Doppelmayr CTEC inc

SUBJECT: Bulletin No. SB-03-006

CHAIR NUMBER PLATES

Fig. 1 Critical areas of towers and cross arms

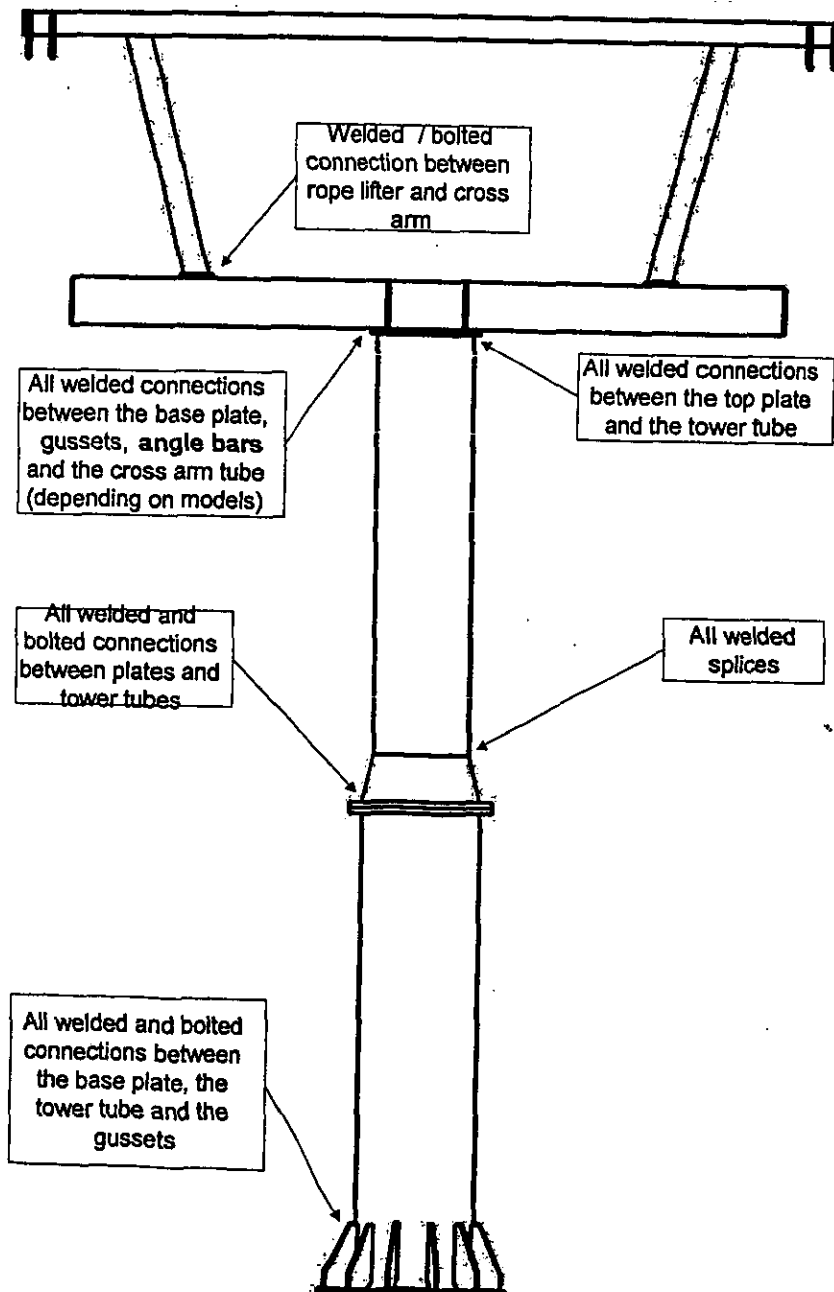
Recently, cracking was observed in the cross arm of a negatively loaded tower. The crack started at the end of the angle gusset welded on the attachment plate and progressed into the cross arm tubing. It was also observed that the lift in question was (or had been) equipped with **urethane after-market sheave liners**.

- Ensure that periodic inspections by qualified personnel have been properly conducted as per Doppelmayr CTEC manuals and applicable local regulations.
- Ensure that inspections included the critical areas mentioned in this bulletin (see Figure 1). If not, perform a thorough visual inspection of all towers and cross arms and pay special attention to the critical areas shown in Figure 1.
- In case of doubt during visual inspection, perform a magnetic particle inspection of the suspect areas.
- **Replace any urethane or similar after-market liners installed on your line.**

- If you detect a crack during your inspection, contact your Doppelmayr CTEC representative for repair procedure or replacement. **Do not operate a lift with defective components.**

Measure 1- Additional closing rail in horse-shoe

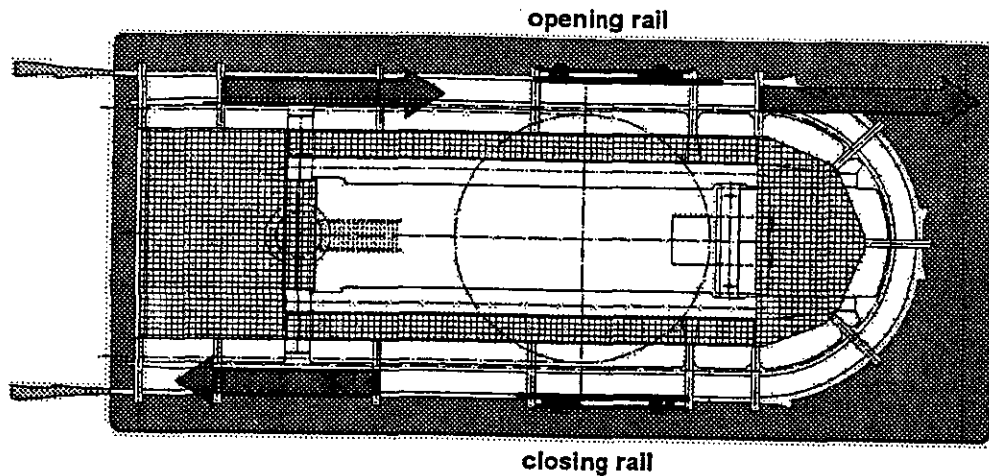
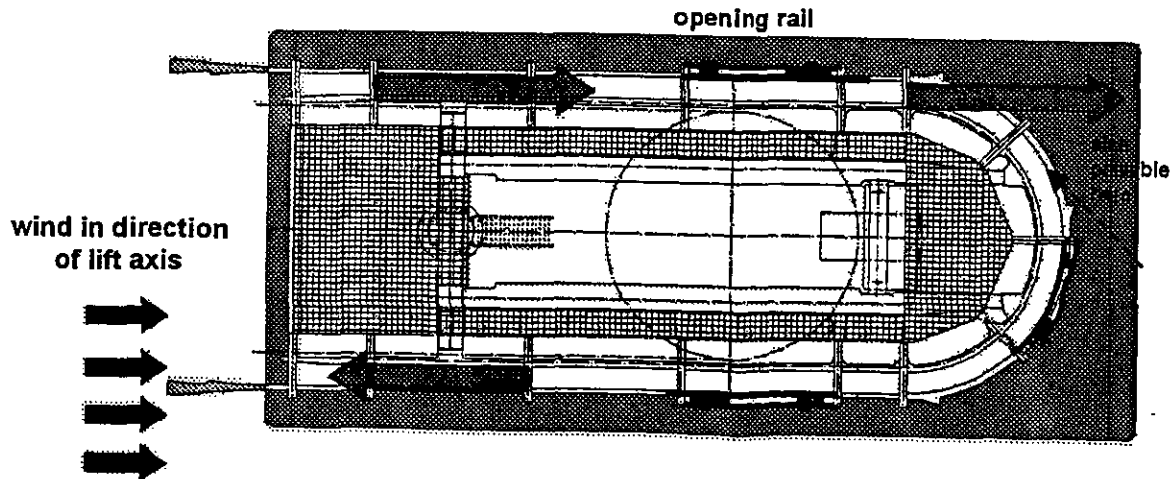
Measures for windy conditions

If the wind blows against the direction of travel, the bubble is closed in the horse-shoe (i.e. not against the wind). This measure greatly reduces the required closing force and retention forces when accelerating the chairs.

Measure 2 - Create wind shelter by positioning the operator room against the main wind direction:

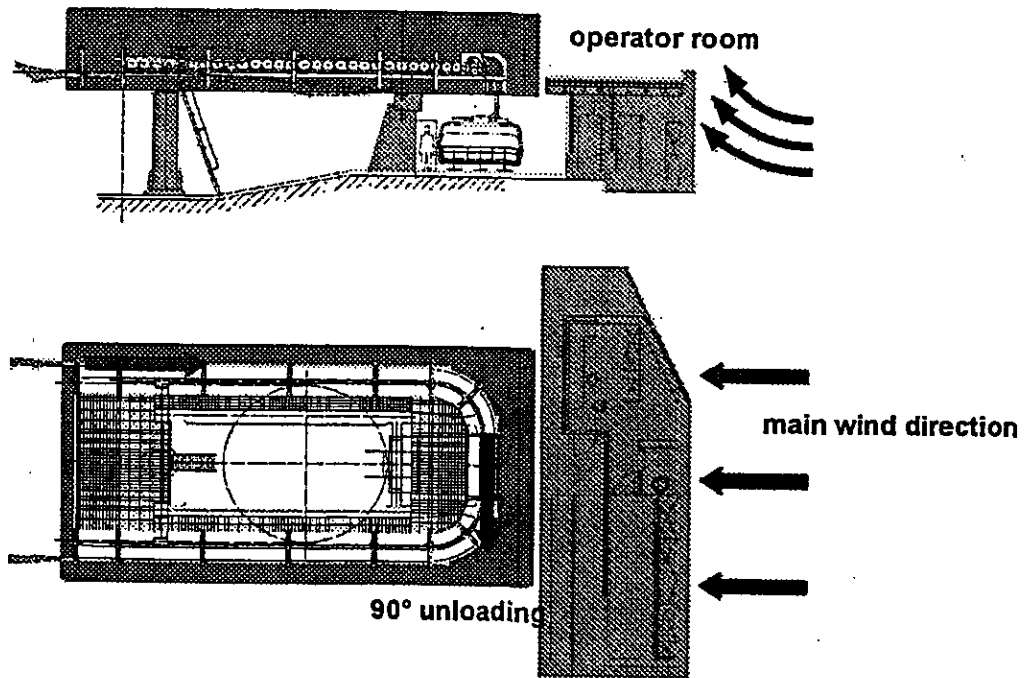
Examples: 6CLD Zebblasbahn, Ischgl; 6CLD Sonnenkar, Kaprun

Measure 3 - Building provides wind shelter:

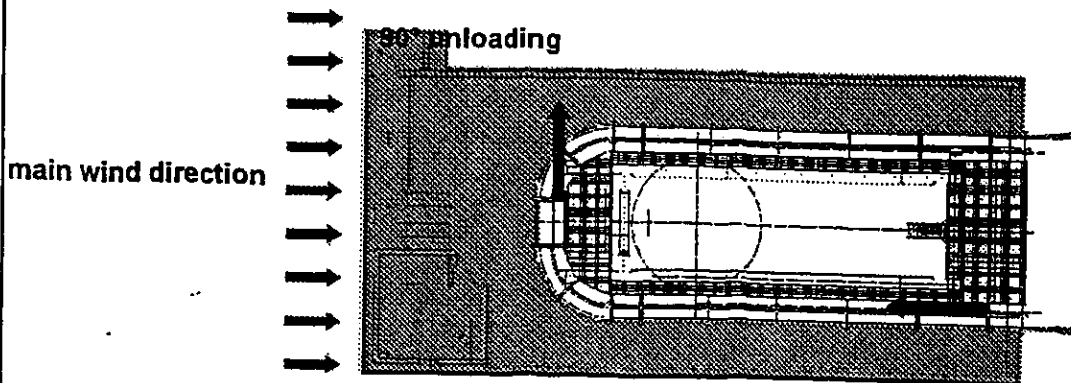
Examples: 6CLD Kriegerhorn, Lech; 6CLD Fernau, Stubai glacier

Measure 5 - Create wind shelter by putting up nets (on existing installations):

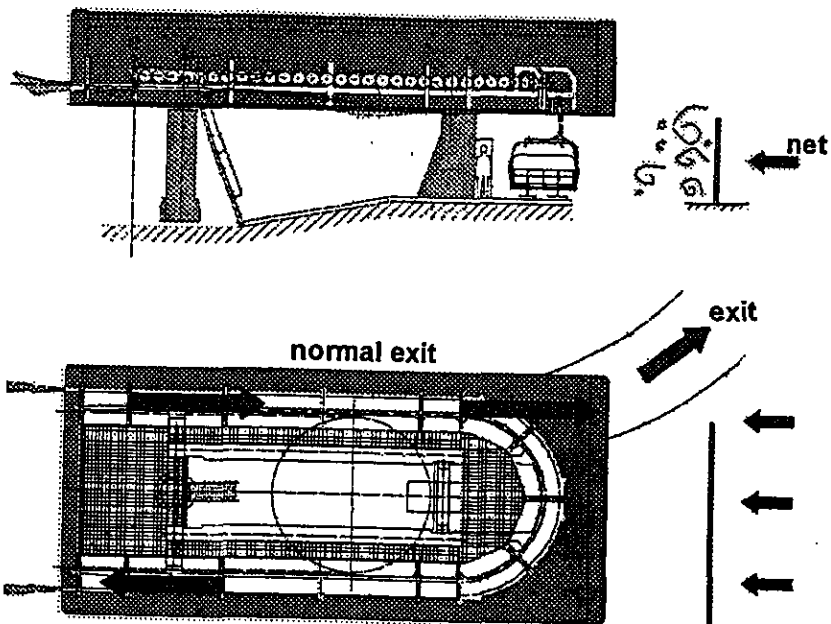
Examples: 6CLD Rätikonbahn, Golm

DS Grip Locking the Bronze Bushing in Position

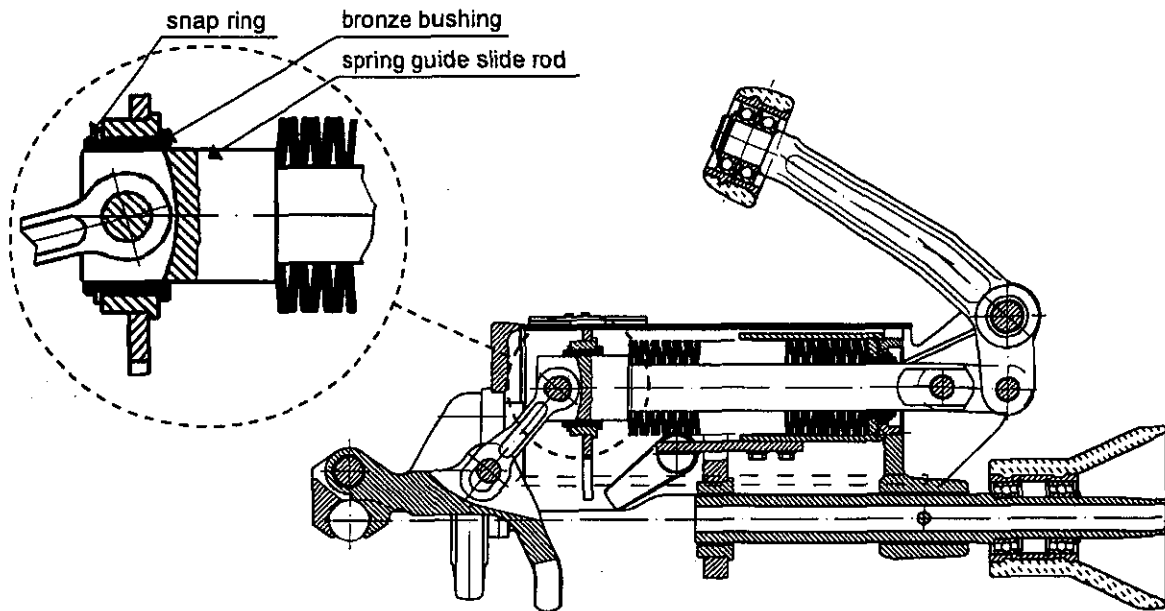
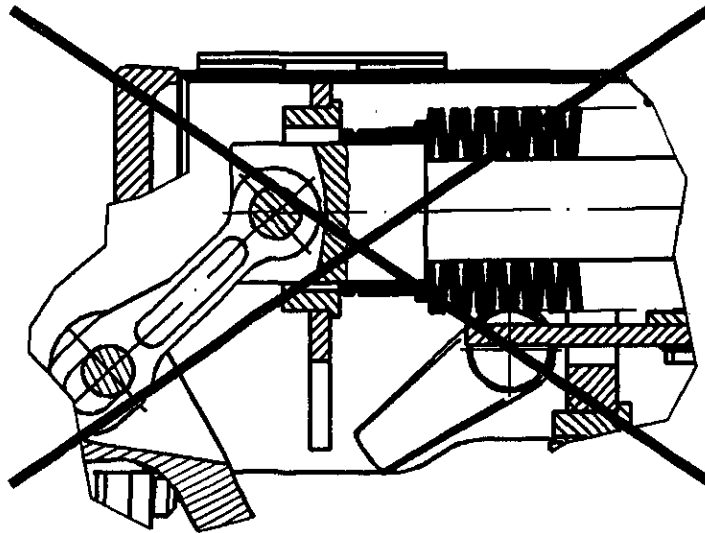
Because of current events we urgently recommend to pay special attention to the correct fastening of the bronze bushing of DS grips by means of the snap ring.

If the snap ring is not fitted correctly or missing, the bronze bushing may creep and as a result the grip may be blocked during the closing procedure!

This means that the grip leaves the station without being completely closed!

Check if the snap ring sits properly, simply by turning it and checking the space between the ends of the snap ring.

Graph 1: Critical areas and critical dimensions, movable jaw

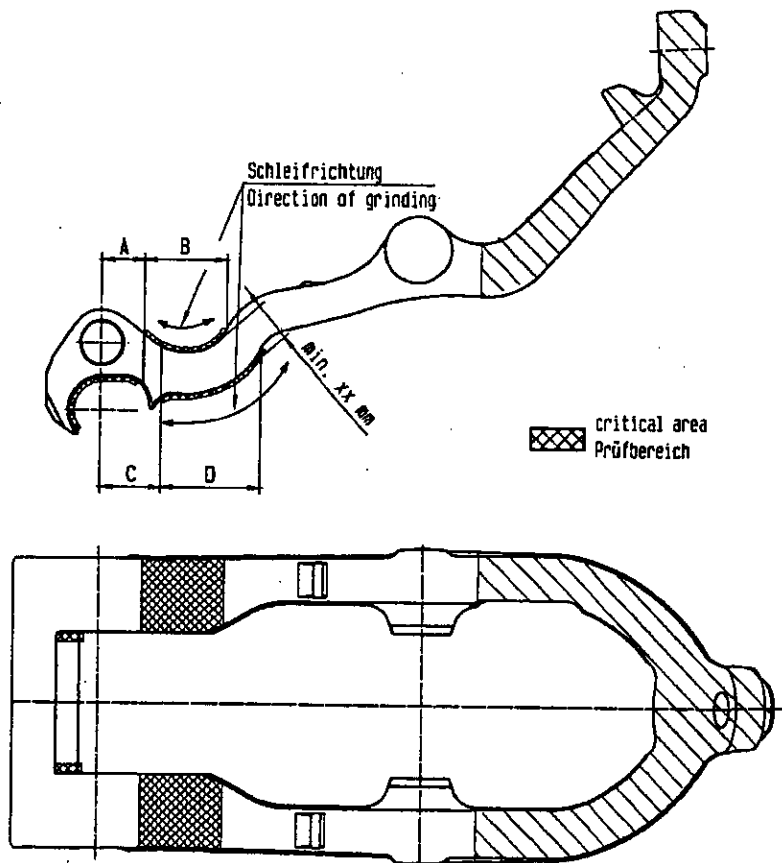
* Grip jaw width: 162 mm

° Grip jaw width: 250 mm

Graph 2: Critical areas and critical dimensions, fixed jaw

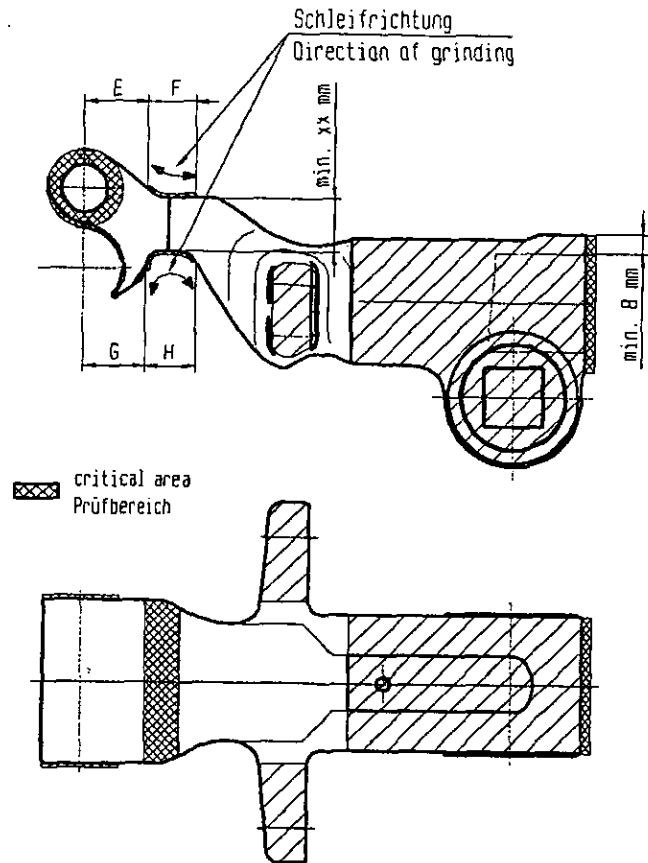
DT 104	DT 106	DT 108
XX	25 mm	29,5 mm	29.5 mm

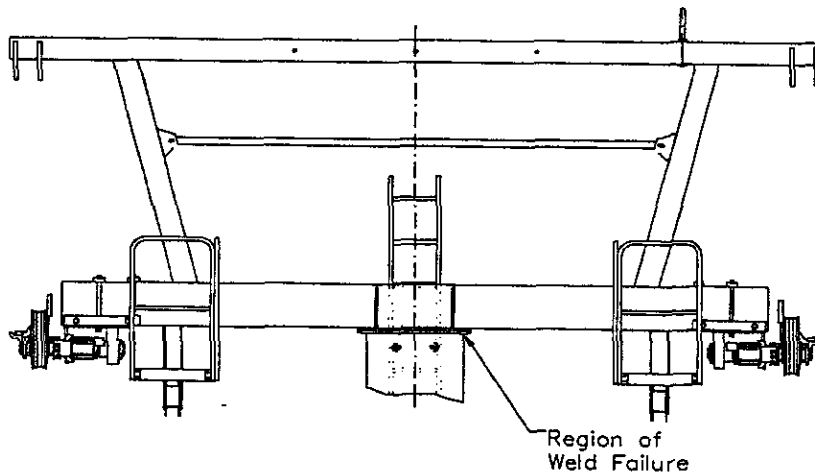
The following schematic depicts the location of the weld that failed.

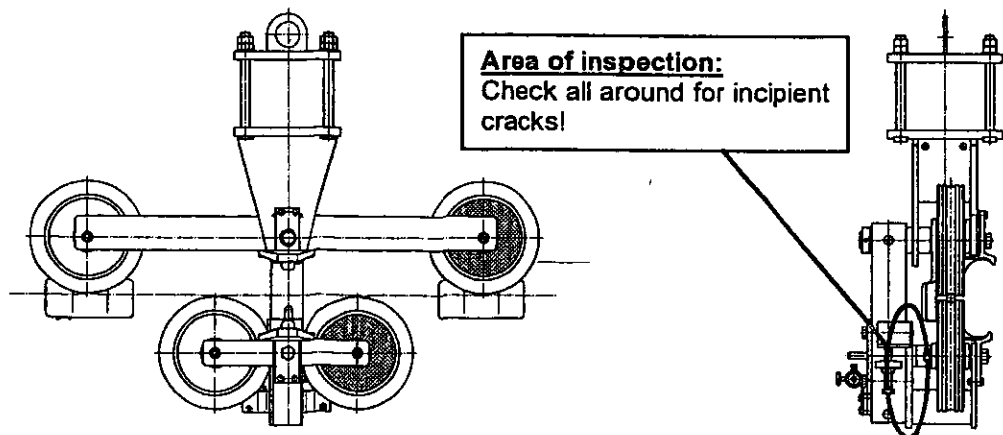
In some cases we have found that the adjustable 2-wheeler evener frame was set (pre-tensioned) beyond the permissible range in order to increase the stability against rope displacement in windy conditions.

This, however, leads to impermissible stress.

4T/2N resp. 8T/4N sheave assembly

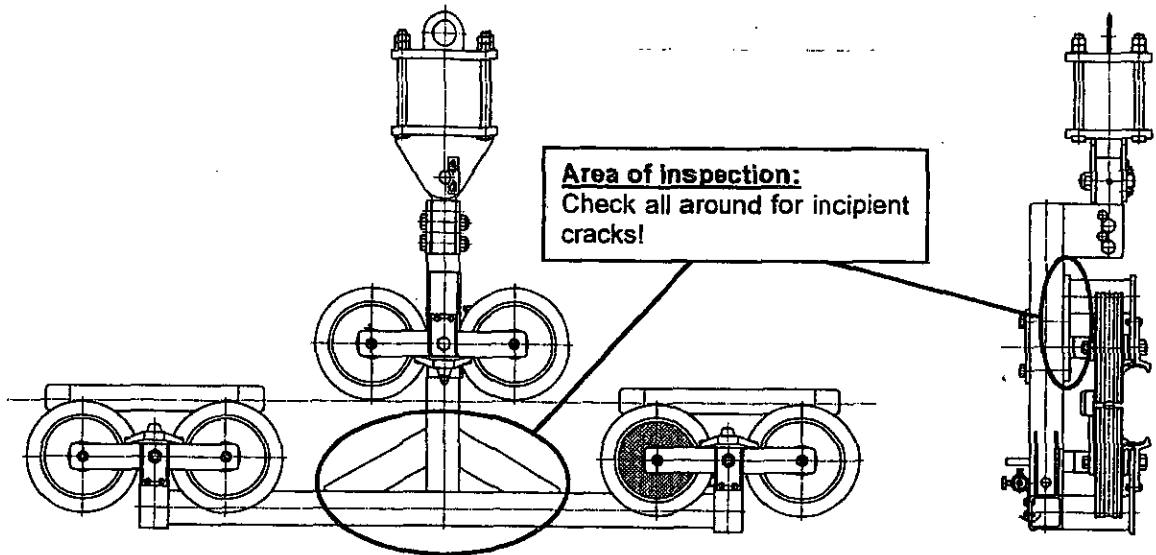
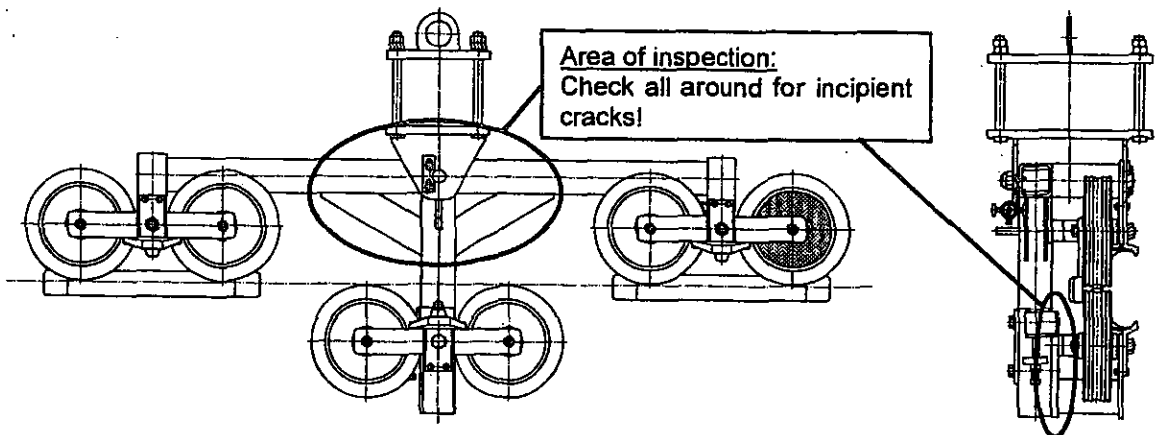
If you find any incipient cracks during the check or obvious vibrations during operation, please inform Doppelmayr immediately so that we can decide the further measures to be taken.

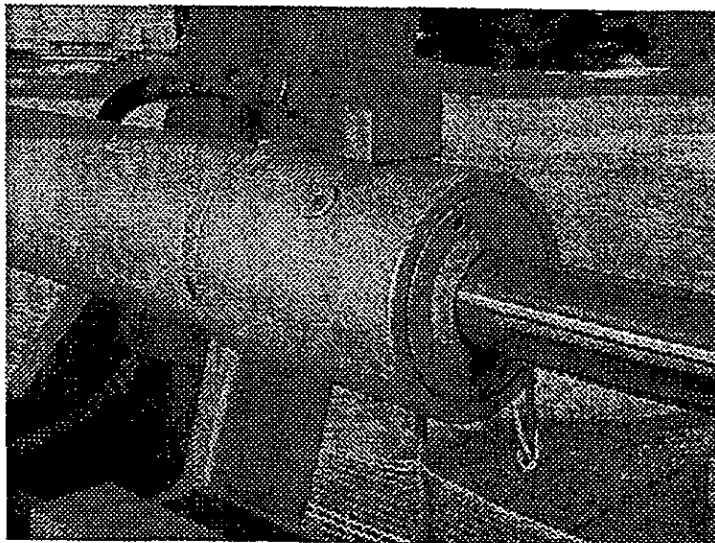
In the past season, a defect occurred on the aluminium body of the pipe failure lock valve of the hydraulic haul rope tensioning unit of an older installation in New Zealand. Consequently, the tensioning cylinder moved right forward to the stop, thus rendering haul rope tensioning inoperational.

The installation concerned has been in operation for 17 years and was among the last ones to be fitted with this type of pipe failure lock valve.

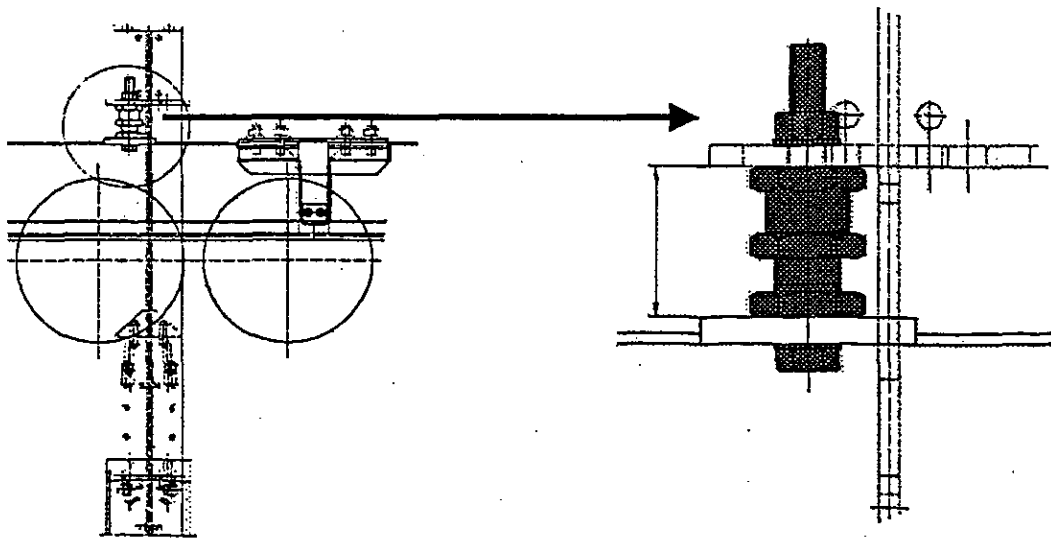
On older UNI stations (not, however, on UNIG) fatigue breaks were found in some suspension bolts in the tyre conveyor support beam.

CATWALK 4T/4D

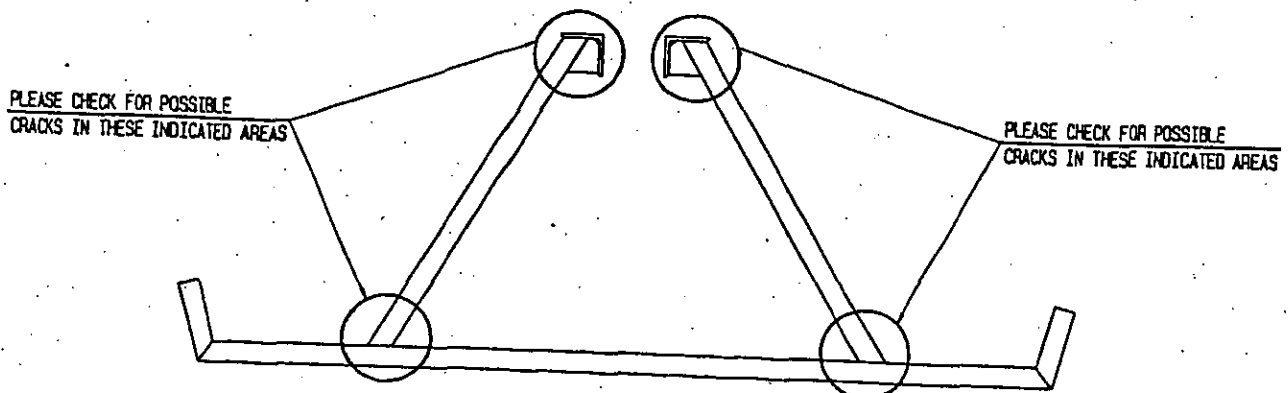
During the last season, one of our customers found indication of cracks on a 4T/4D catwalk during his periodic visual inspection. The catwalk failed by natural vibration at the end of the season. According to our records, you have these types of catwalks on your Doppelmayr 4T/4D sheave assemblies. Therefore, we kindly ask you to inspect your catwalks in the areas as described in drawing below. In case of doubt, perform a non-destructive test by magnetic particles. If any indication of cracks is found, remove the catwalk and report immediately to your Doppelmayr CTEC representative. We thank you in advance for your collaboration on this matter.

5. Chair bail model E / EC sketch

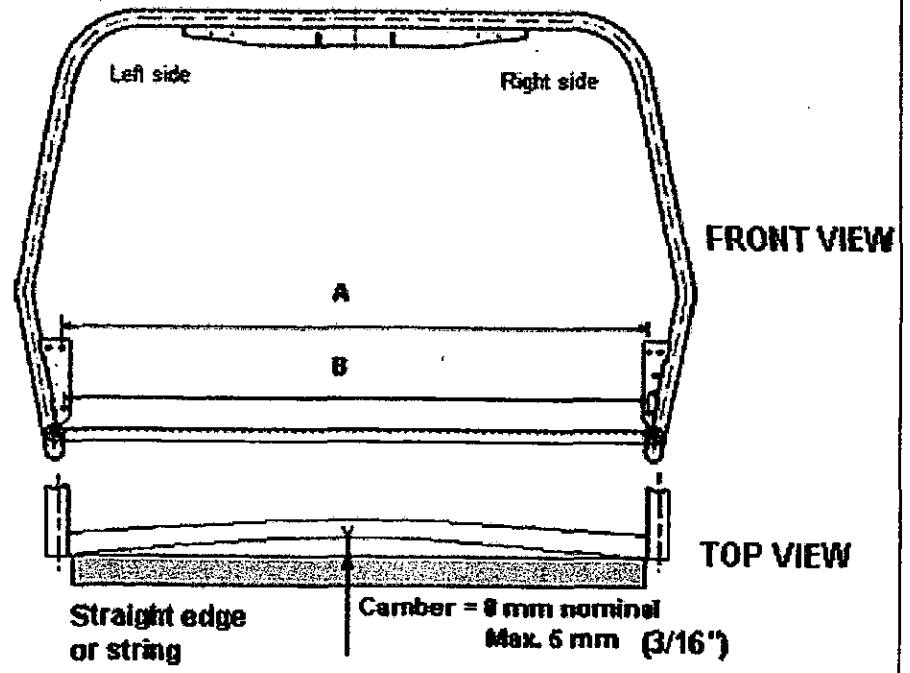
To determine if the chair bail is deformed :

- Measure the camber of the angle bar in the front. If the camber is less than or equal to **5 mm (3/16")** the chair bail is considered to be "conforming"
- If the camber exceeds **5 mm (3/16")** remove the seat back and measure the dimensions **A** and **B**.
- If dimensions **A** or **B** are less than **2002 mm**, the bail is considered as "deformed"
- If dimensions **A** or **B** are equal or greater than **2002 mm**, the bail is considered as "conforming".
